RE: **PETITION NO. 1545** – The Connecticut Light and Power Company d/b/a Eversource Energy declaratory ruling, pursuant to Connecticut General Statutes §4-176 and §16-50k, for the proposed Wawecus Junction to Montville Junction Upgrade Project consisting of the replacement of electric transmission line structures along its existing 8-mile electric transmission line right-of-way shared by its existing 115-kilovolt (kV) Nos. 1000, 1070, 1080 and 1090 Lines between Wawecus Junction in Norwich and Montville Junction in Montville, Connecticut, and related electric transmission line and substation improvements.

**Re: PETITION NO. 1545** – The Connecticut Light and Power Company d/b/a Eversource Energy petition for a declaratory ruling, pursuant to Connecticut General Statutes §4-176 and §16-50k, for the proposed Wawecus Junction to Montville Junction Upgrade Project consisting of the replacement of electric transmission line structures along its existing 8-mile electric transmission line right-of-way shared by its existing 115-kilovolt (kV) Nos. 1000, 1070, 1080 and 1090 Lines between Wawecus Junction in Norwich and Montville Junction in Montville, Connecticut, and related electric tra

**EVERSOURCE ENERGY**  
**Wawecus Junction to Montville Junction Upgrade Project**  
 Montville, CT  
 Map Sheet 08 of 15  
 Date: June, 2023

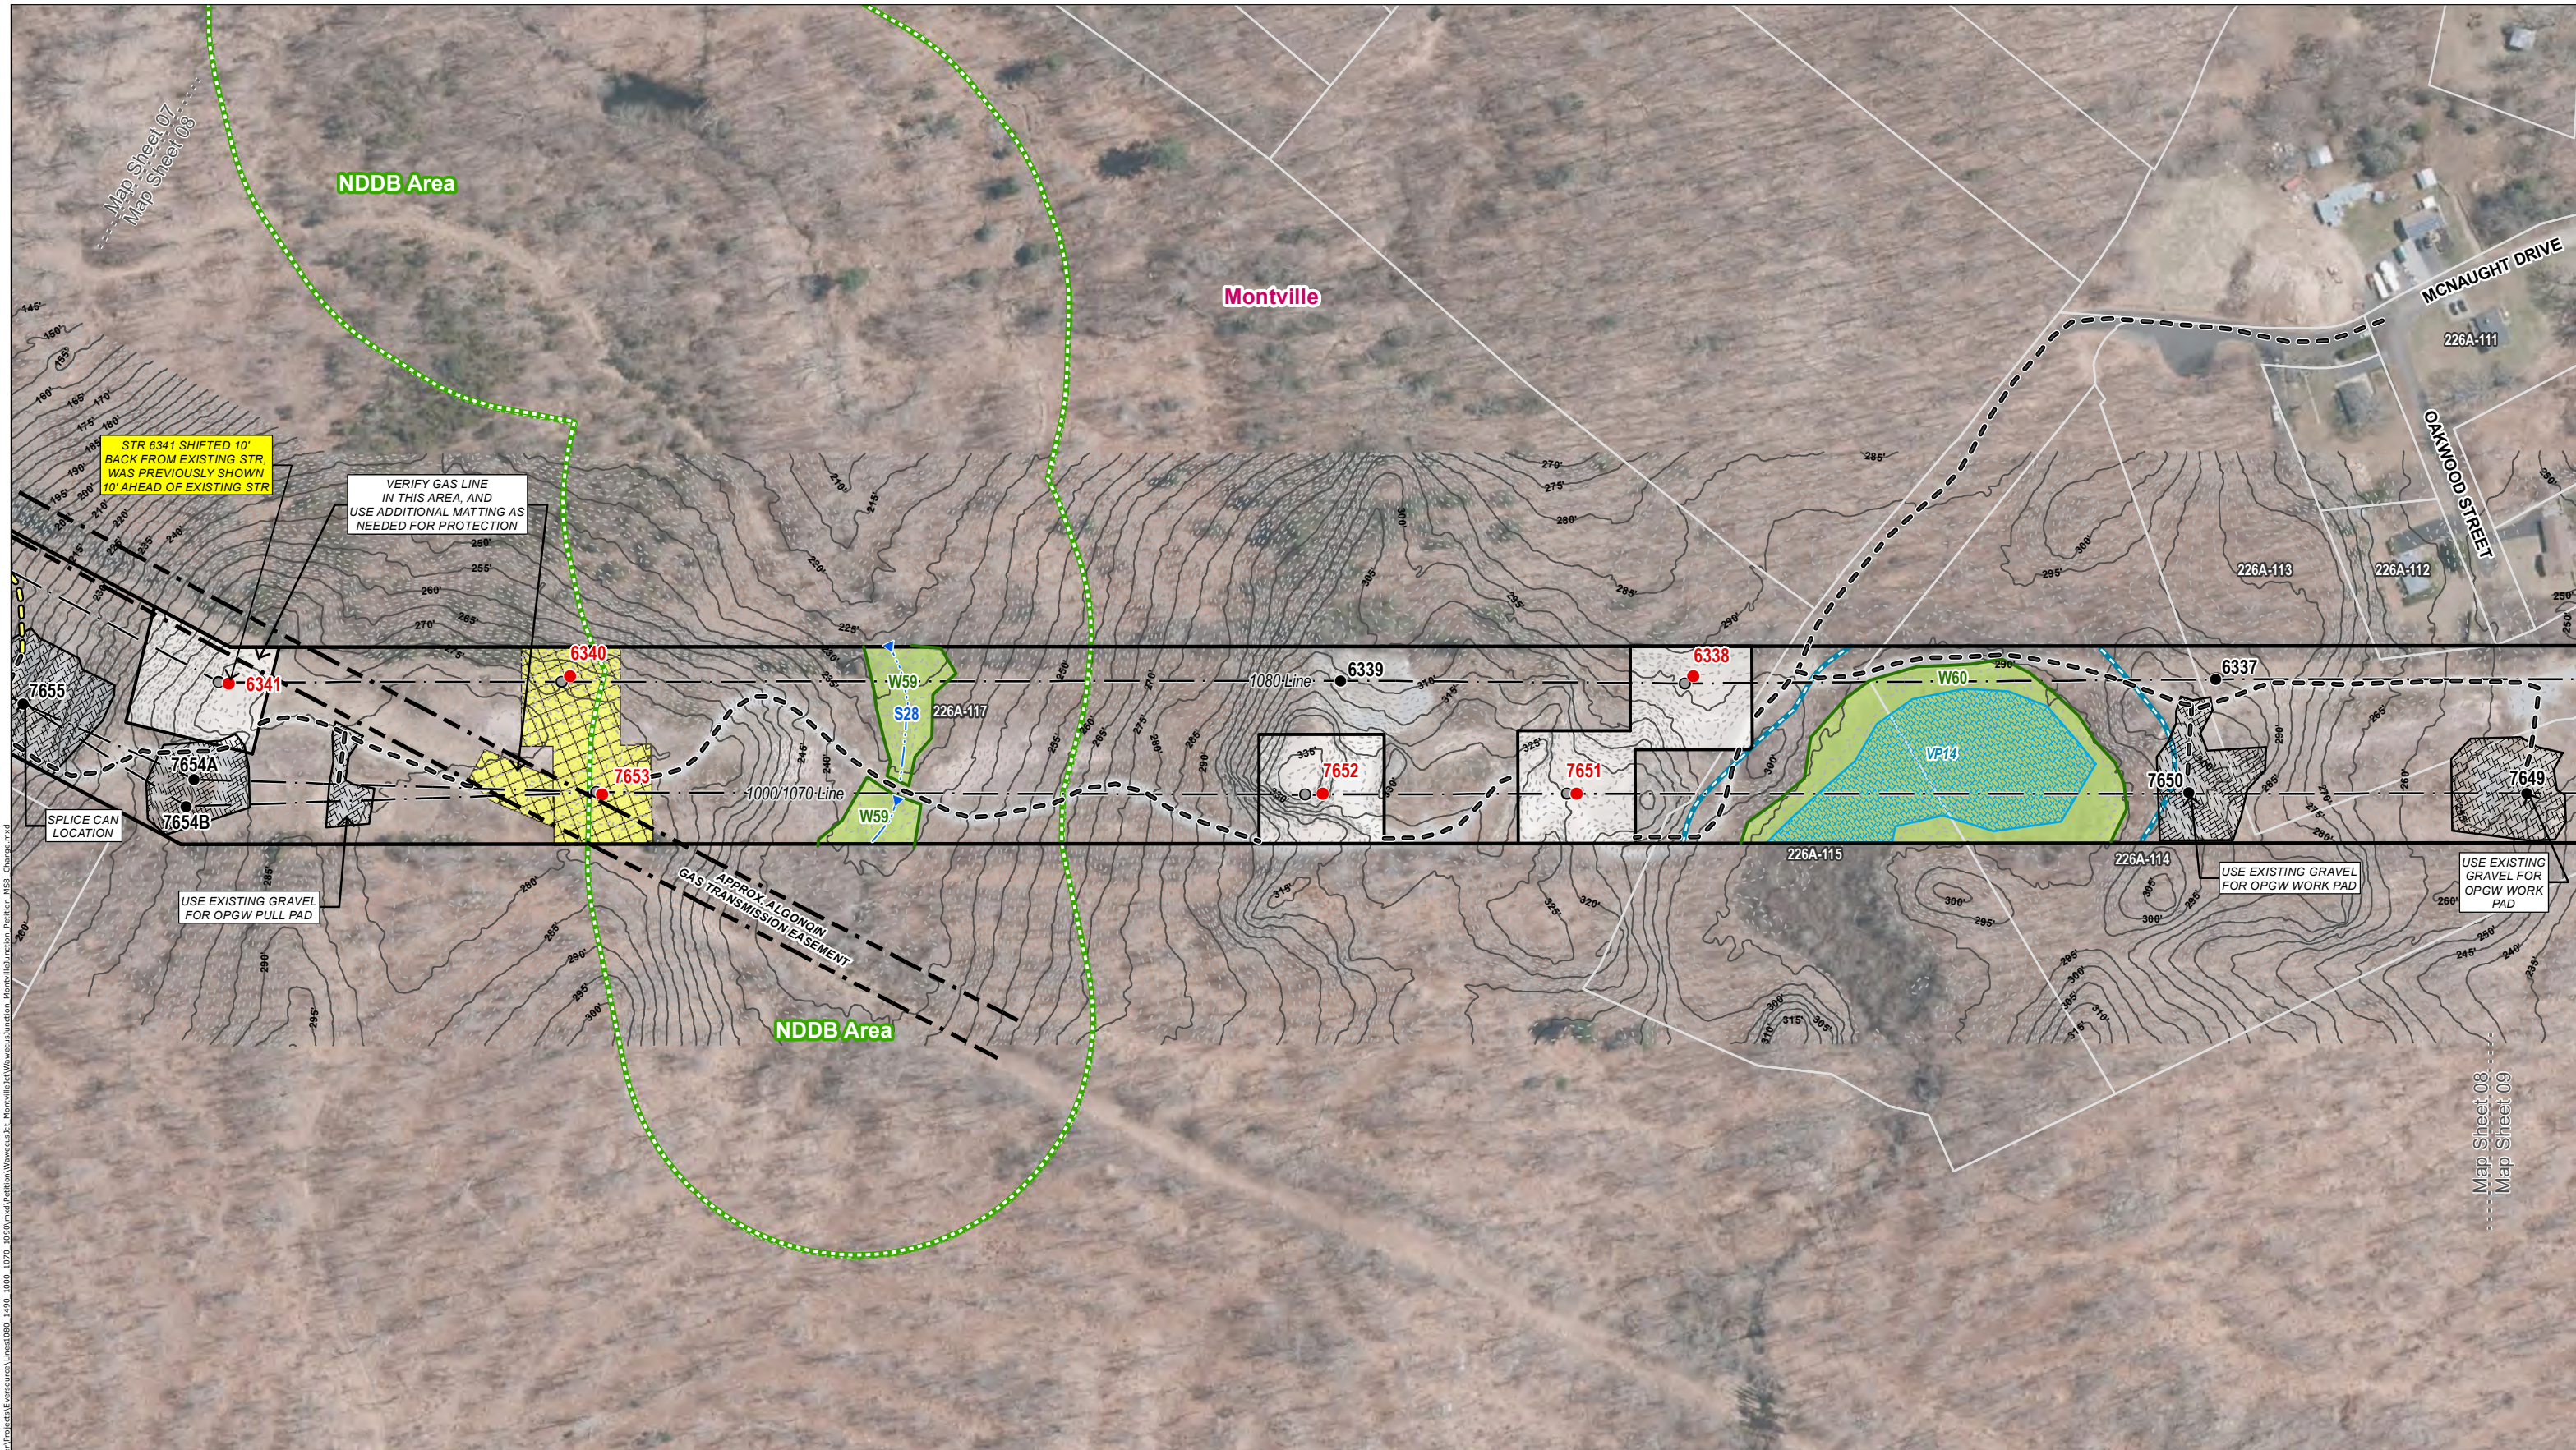
- Shift Replacement Structure 6341 to 10 feet back from existing structure, instead of 10 feet ahead, to accommodate improved working clearances (revised Map Sheets 7 & 8)
- Modify a portion of the off-ROW access road surface, between Gallivan Lane and Structure 6333, to add matting in lieu of gravel to mitigate the potential for rutting the agricultural field, as determined in consultation with the Property Owner (revised Map Sheet 9)
- Shift the matted access road to the south side of Structure 7645 to avoid traversing a berm, and instead enter the gravel work pad at an existing break location in the berm (revised Map Sheet 9)

NO.	DATE	REVISIONS
1	6/16/23	Str 6341 Shifted Back 10' from Existing Str. Was Previously Shown 10' Ahead of Existing Str

- a) Shift replacement Structure 6341 from approximately 10 feet north of the existing structure to approximately 10 feet south of the existing structure, to improve working clearances;
- b) Modify a portion of the off-ROW access road surface, between Gallivan Lane and Structure 6333, to add matting in lieu of gravel to mitigate the potential for ruts in the agricultural field; and
- c) Shift a portion of the matted access road towards the southern side of the Structure 7645 to avoid traversing a berm.

Pursuant to Condition No. 1 of the Council's January 20, 2023 Declaratory Ruling, the specified requests for project changes are hereby approved. This approval applies only to the project changes in the correspondence dated June 19, 2023.
